# UNITED STATES PATENT AND TRADEMARK OFFICE

10/552,376

<b>Office Action Summary</b>	<b>Application No.</b> 10/552,376	<b>Applicant(s)</b> CHEN, HUA	
	<b>Examiner</b> Christopher Verdier	<b>Art Unit</b> 3745

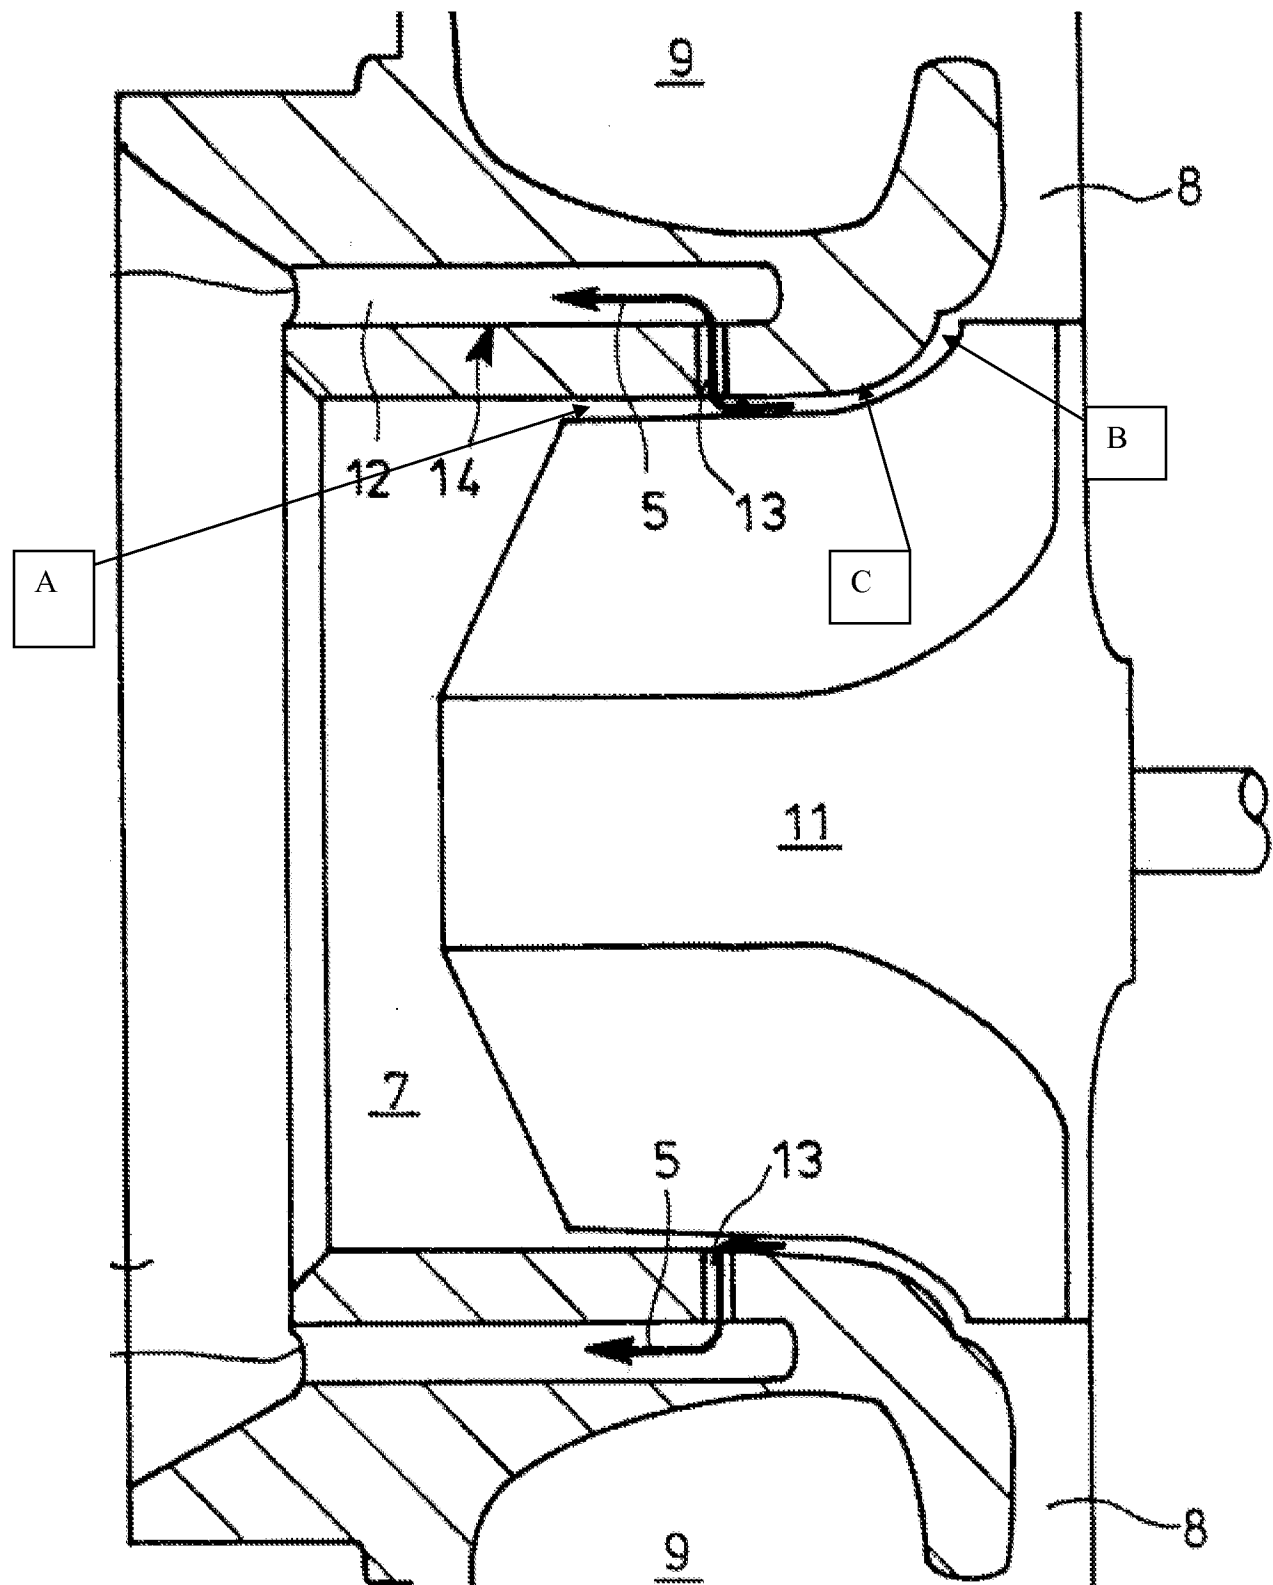
Claims 1, 15/1, and 18 are rejected under 35 U.S.C. 102(b) as being anticipated by Mitsubori 5,246,335 (figure 2). Disclosed is a compressor comprising a compressor wheel having a hub 11, unnumbered free-ended compressor blades and being mounted for rotation on an unnumbered shaft, each blade being characterized by a free-ended outer edge, an upstream leading edge and a downstream trailing edge, and a shroud 4 mounted adjacent and around the outer edges of the compressor blades and defining a gas flow path between the shroud and the hub from a compressor inlet 6 to a diffuser outlet 8, through which the blades rotate with respect

to the shroud, wherein in cross-section the shroud forms a surface A along the flow path, the surface being characterized by a profile that includes a relative discontinuity B in the region of the trailing edge, wherein the discontinuity forms a downstream-facing blocking face adapted to impede an upstream flow of gas between the shroud and the wheel, the blocking face extending across the flow path to form a sharp edge connecting the blocking face to a smoothly curving surface C along the gas flow path upstream of the discontinuity. The compressor is included with a turbocharger. The discontinuity is in the form of a groove. Note the annotated figure below.

**FIG. 4**

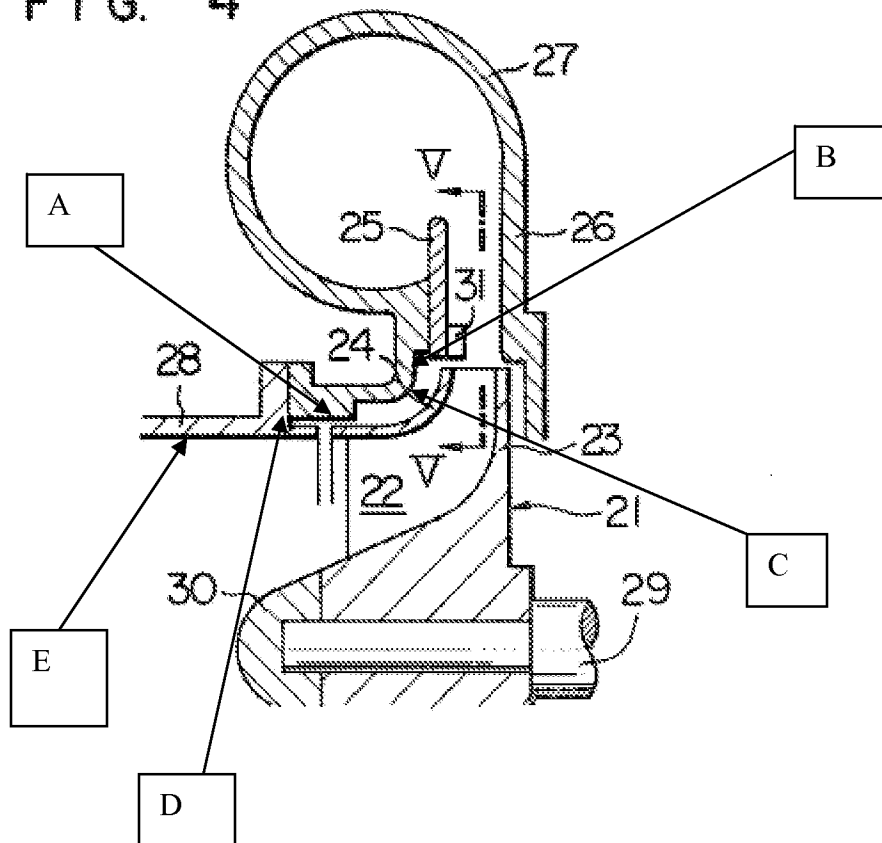
Claims 1, 4, 5, 6, 9, 11, 12/6, 13/6, 14/6, 15/6, 12/9, 13/9, 14/9, 12/4, 13/4, 14/4, 15/1, 15/4, 15/11, and 18 are rejected under 35 U.S.C. 103(a) as being unpatentable over Yoshinaga 4,395,197 in view of Jones 3,893,787. Yoshinaga disclosed a compressor substantially as claimed, comprising a compressor wheel 21 having a hub 1, compressor blades 22 and being mounted for rotation on a shaft 29, each blade being characterized by an outer edge, an upstream leading edge and a downstream trailing edge, and a shroud 27/28 mounted adjacent (note that adjacent does not require that two elements be immediately next to one another) and around the outer edges of the compressor blades and defining a gas flow path between the shroud and the hub from a compressor inlet to a diffuser outlet, through which the blades rotate with respect to the shroud, wherein in cross-section the shroud forms a surface A along the flow path, the surface being characterized by a profile that includes a relative discontinuity B in the region of the trailing edge, wherein the discontinuity forms a downstream-facing blocking face adapted to impede an upstream flow of gas between the shroud and the wheel, the blocking face extending across the flow path to form a sharp edge connecting the blocking face to a smoothly curving

surface C along the gas flow path upstream of the discontinuity. The cross-section profile of the shroud surface along the flow path is further characterized by a second relative discontinuity D that is in the region of the leading edge, wherein the second relative discontinuity forms a second downstream-facing blocking face adapted to impede an upstream flow of gas between the shroud and the wheel, the second blocking face extending across the flow path to form a sharp edge connecting the second blocking face to a second smooth surface E upstream of the second discontinuity. The second discontinuity is located upstream of the leading edge of the wheel blades. The second discontinuity is spaced from the leading edge of the wheel blades by a distance of the same order as the axial clearance of the trailing edge from the compressor housing. The or each downstream-facing blocking face comprises a planar surface cut into the curving surface. The second downstream-facing blocking face comprises a planar surface cut into the curving surface, and the planar surface is perpendicular to the axis of the shaft. The radial extent of the second discontinuity is of the same order as the radial clearance between the trailing edge and the housing. The sizes of the first and second discontinuities are closely similar. The discontinuity is in the form of a groove. The shapes of the first and second discontinuities are closely similar. Concerning claim 15, the term “turbocharger” is recited in the preamble of the claim and has not been given patentable weight. A preamble is generally not accorded any patentable weight where it merely recites the purpose of a process or the intended use of a structure, and where the body of the claim does not depend on the preamble for completeness but, instead, the process steps or structural limitations are able to stand alone. See *In re Hirao*, 535 F.2d 67, 190 USPQ 15 (CCPA 1976) and *Kropa v. Robie*, 187 F.2d 150, 152, 88 USPQ 478, 481 (CCPA 1951). Note the annotated figure below.

However, Yoshinaga does not disclose that the compressor blades are free-ended, with each blade having a free-ended outer edge (claim 1). Rather, the compressor blades have a shroud 24.

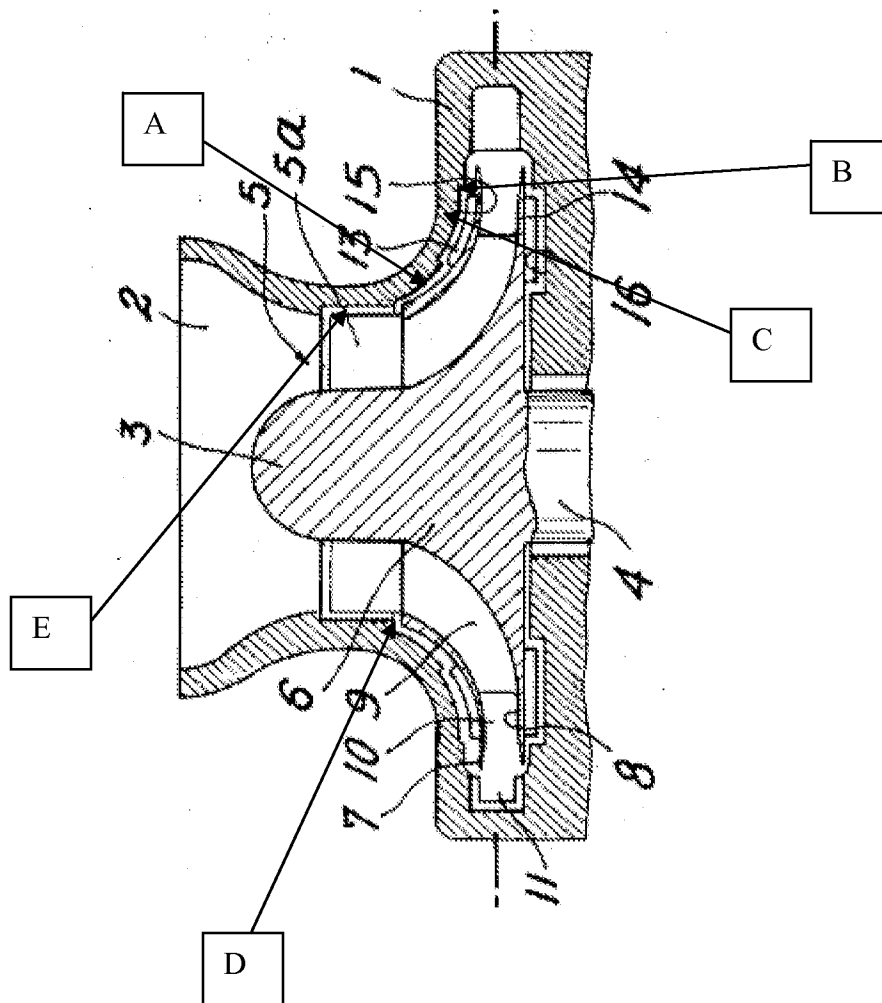
Claims 1, 4, 5, 9, 11, 13/9, 14/9, 13/4, 14/4, 15/1, 15/4, 15/11, and 18 are rejected under 35 U.S.C. 103(a) as being unpatentable over Fabri 3,824,029 in view of Jones 3,893,787. Fabri discloses a compressor substantially as claimed, comprising a compressor wheel 3/6 having a hub 3 and compressor blades 9 and being mounted for rotation on a shaft 4, each blade being characterized by an outer edge, an upstream leading edge and a downstream trailing edge, and a shroud 1 mounted adjacent (note that adjacent does not require that two elements be immediately next to one another) and around the outer edges of the compressor blades and defining a gas flow path between the shroud and the hub from a compressor inlet to a diffuser outlet, through which the blades rotate with respect to the shroud, wherein in cross-section the shroud forms a surface A along the flow path, the surface being characterized by a profile that includes a relative discontinuity B in the region of the trailing edge, wherein the discontinuity forms a downstream-

facing blocking face adapted to impede an upstream flow of gas between the shroud and the wheel, the blocking face extending across the flow path to form a sharp edge connecting the blocking face to a smoothly curving surface C along the gas flow path upstream of the discontinuity. The cross-section profile of the shroud surface along the flow path is further characterized by a second relative discontinuity D that is in the region of the leading edge, wherein the second relative discontinuity forms a second downstream-facing blocking face adapted to impede an upstream flow of gas between the shroud and the wheel, the second blocking face extending across the flow path to form a sharp edge connecting the second blocking face to a second smooth surface E upstream of the second discontinuity. The second discontinuity is located upstream of the leading edge of the wheel blades. The or each downstream-facing blocking face comprises a planar surface cut into the curving surface. The second downstream-facing blocking face comprises a planar surface cut into the curving surface, and the planar surface is perpendicular to the axis of the shaft. The sizes of the first and second discontinuities are closely similar. The shapes of the first and second discontinuities are closely similar. Concerning claim 15, the term “turbocharger” is recited in the preamble of the claim and has not been given patentable weight. A preamble is generally not accorded any patentable weight where it merely recites the purpose of a process or the intended use of a structure, and where the body of the claim does not depend on the preamble for completeness but, instead, the process steps or structural limitations are able to stand alone. See *In re Hirao*, 535 F.2d 67, 190 USPQ 15 (CCPA 1976) and *Kropa v. Robie*, 187 F.2d 150, 152, 88 USPQ 478, 481 (CCPA 1951). Note the annotated figure below.

However, Fabri does not disclose that the compressor blades are free-ended, with each blade having a free-ended outer edge (claim 1). Rather, the compressor blades have a shroud 7.
